SUBJECT: TOPIC II-3.A, HYDROLOGIC DESCRIPTION AND TOPIC II-3.B,  
(PARTIAL), FLOODING POTENTIAL AND PROTECTION REQUIREMENTS  
(YANKEE ROWE)

SEP DRAFT SAFETY TOPIC EVALUATION  
YANKEE ROWE NUCLEAR POWER STATION

TOPICS II-3.A, HYDROLOGIC DESCRIPTION  
TOPIC II-3.B, (PARTIAL), FLOODING POTENTIAL AND PROTECTION REQUIREMENTS

Figure 3.2.5 Harriman Spillway - Plan and Sections

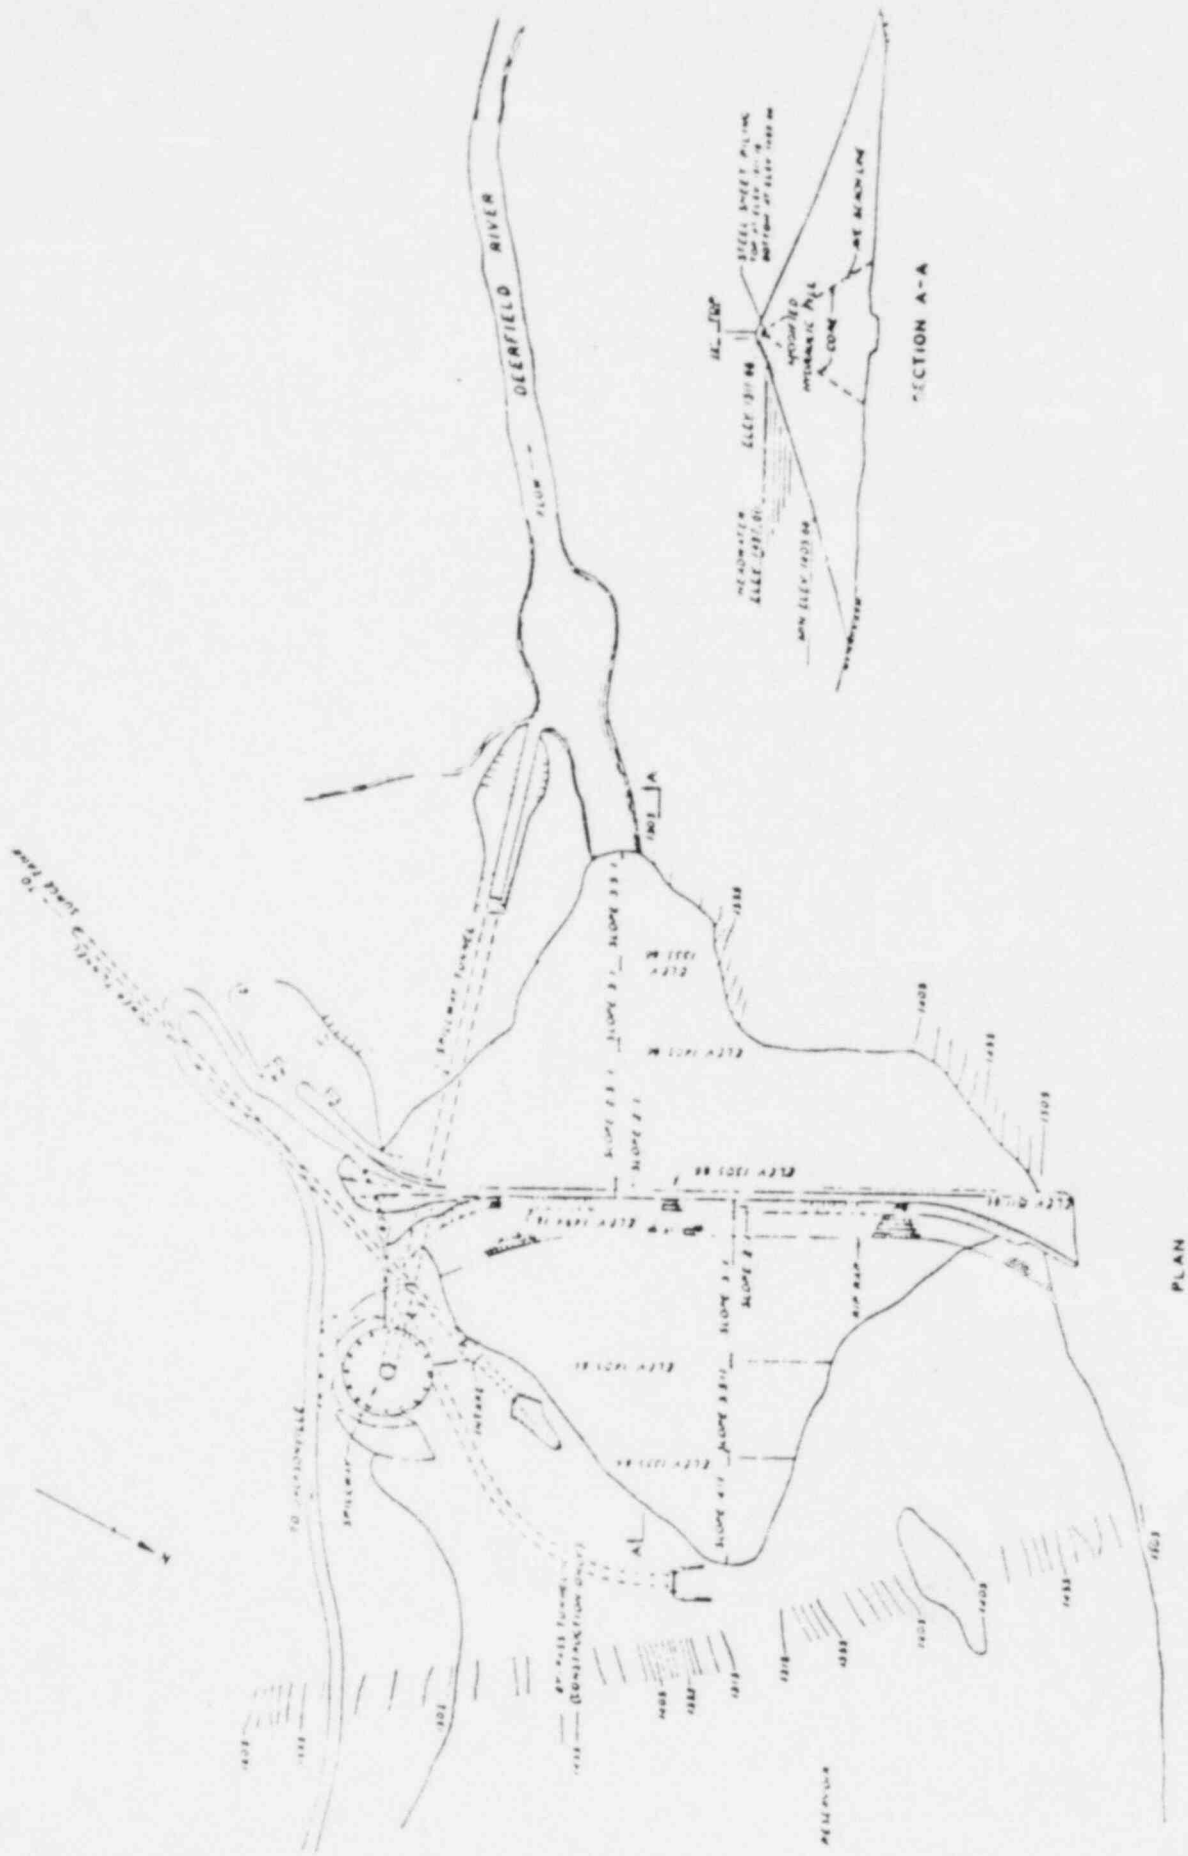
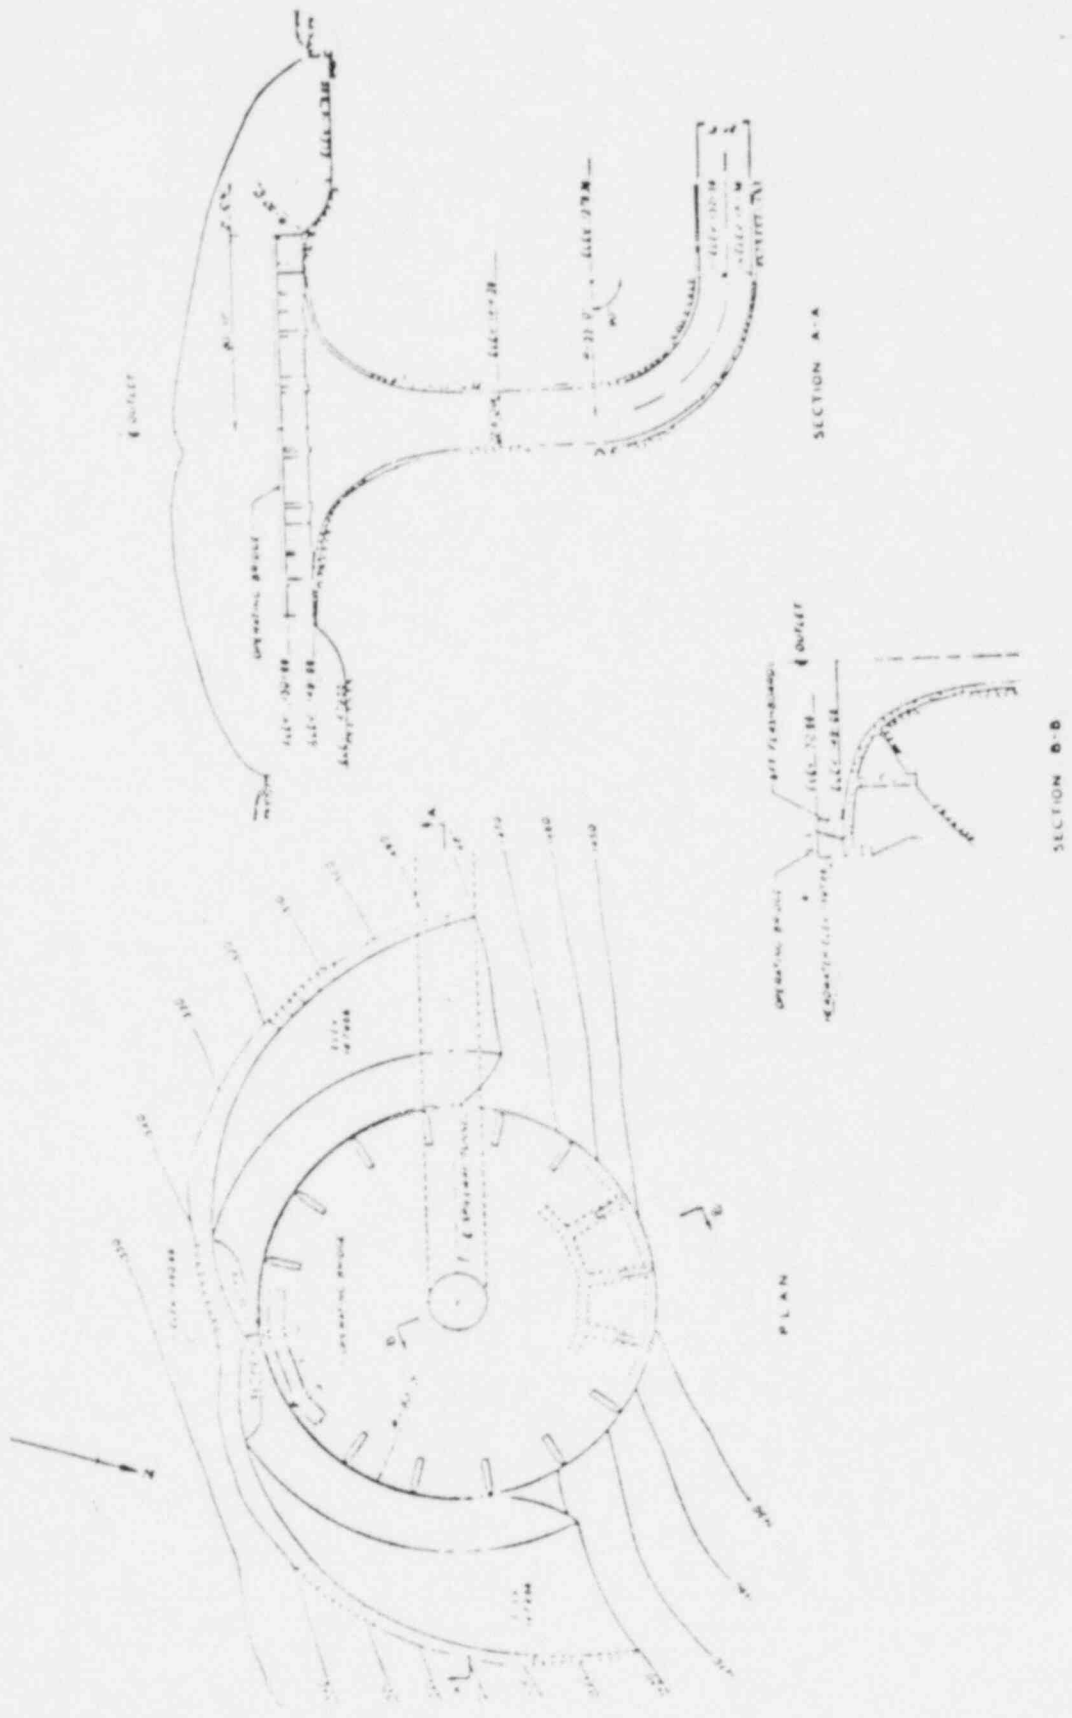
The staff has some reservations with respect to the spillway for Harriman Reservoir. This spillway is the "Morning Glory" type which is designed to operate with a small change in discharge for a large range in heads. The spillway is located in the corner of the reservoir and very close to the dam and southern bank of the reservoir. This location would be conducive to debris accumulation and potential blockage, especially for rare floods that will carry many large trees and other debris downstream. These spillways are also noted for undesirable discharge characteristics at reservoir levels above the design value. The Harriman spillway was designed for a reservoir elevation of 1498.6 feet msl. The dam has been raised subsequently, and predicted levels could be as high as elevation 1525 feet msl. When these type spillways are subjected to heads above the design value, there is possibility of shifting control between weir, orifice and full pipe (pressure flow) with the associated uncertain discharge capability, slug flow, vortices, cavitation, and vibration. There is another uncertainty with respect to the rather narrow discharge channel immediately downstream of the tunnel outlet. The unknown is whether the narrow channel could submerge the outlet at higher flows, thus forcing a hydraulic jump in the conduit and thus reducing capacity.

they were it is very difficult to predict, with a model, the flow characteristics for this type of spillway, for greater than design conditions. In light of the many uncertainties with this spillway, we limited the assumed discharge to the capacity of the riser throat as an orifice. This is about a 25% reduction in capacity at the higher heads.

Figure 3.2.8 Sherman Spillway — Plan and Sections

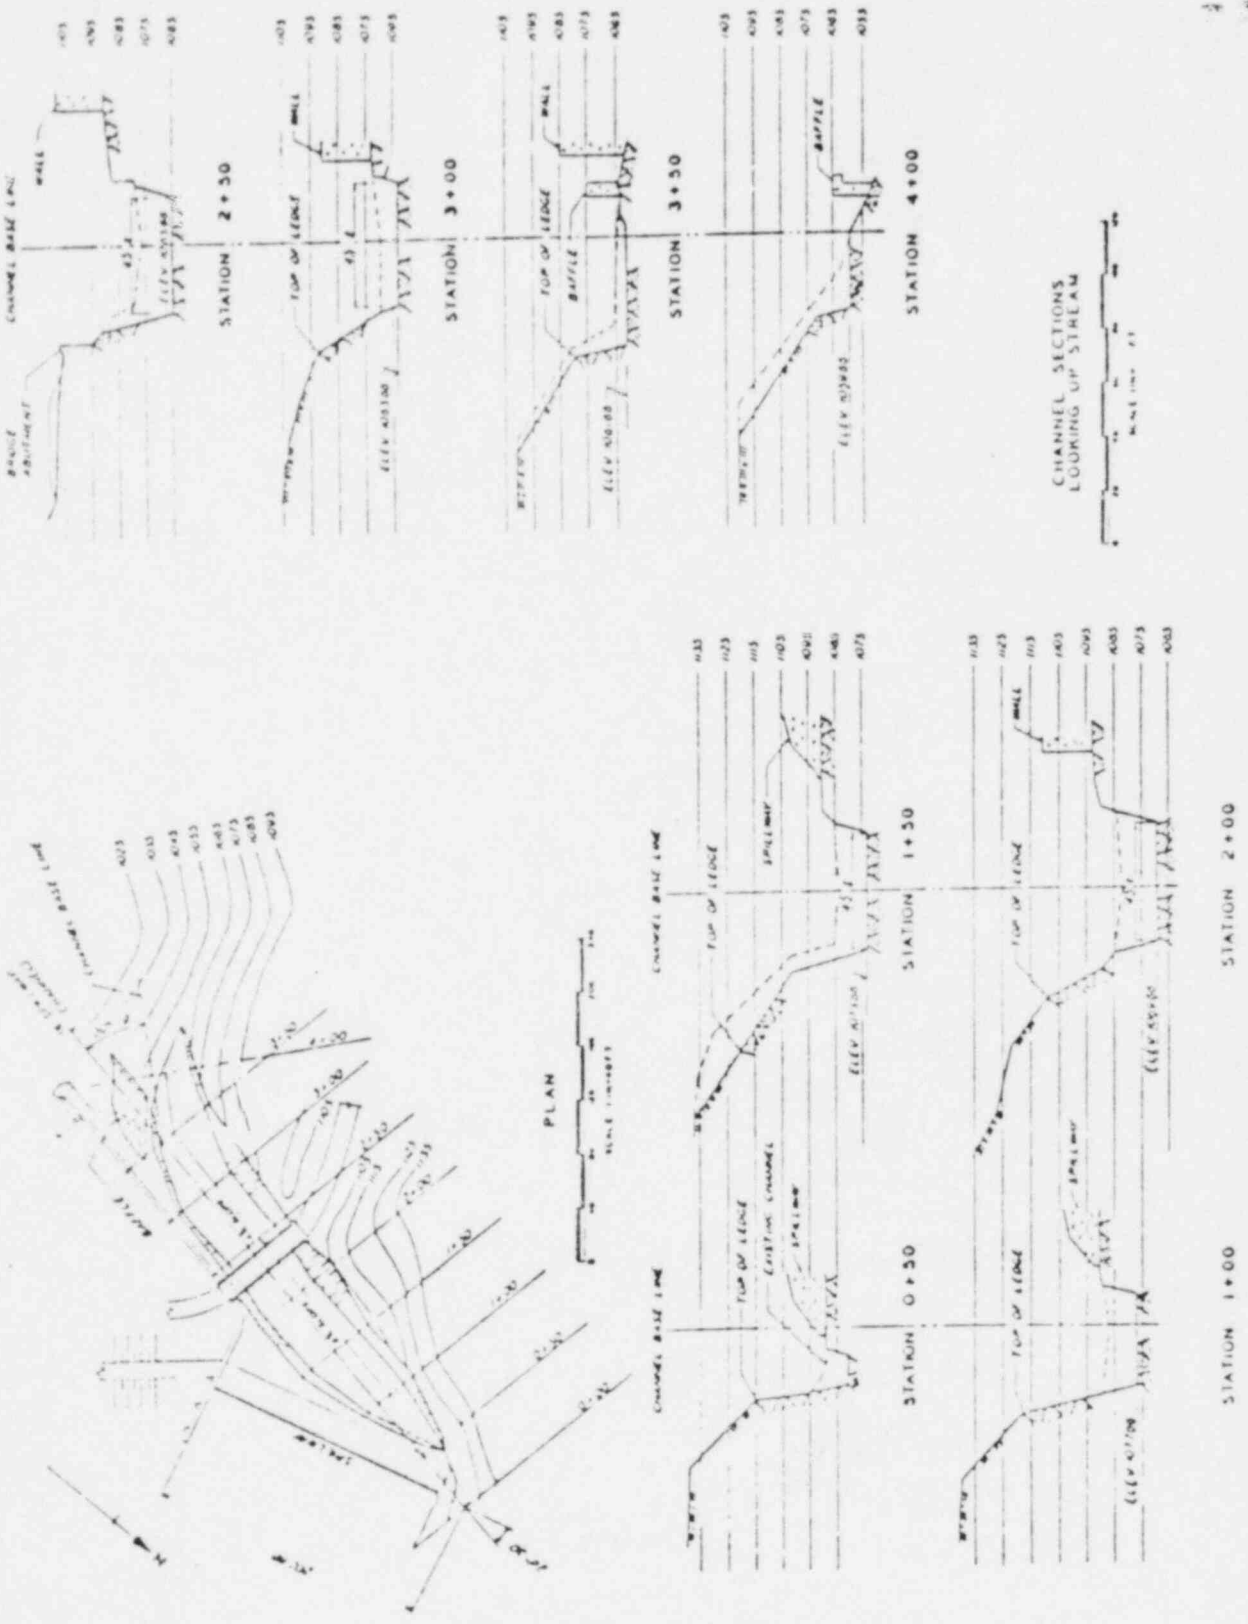
The spillway for Sherman Dam has a rather narrow discharge channel downstream of the crest. Downwater computations for this spillway indicate the possibility of hydraulic jumps or turbulent flow conditions at very high discharges. Depending on the resolutions of other more serious problems, this issue may be investigated more thoroughly at another time.
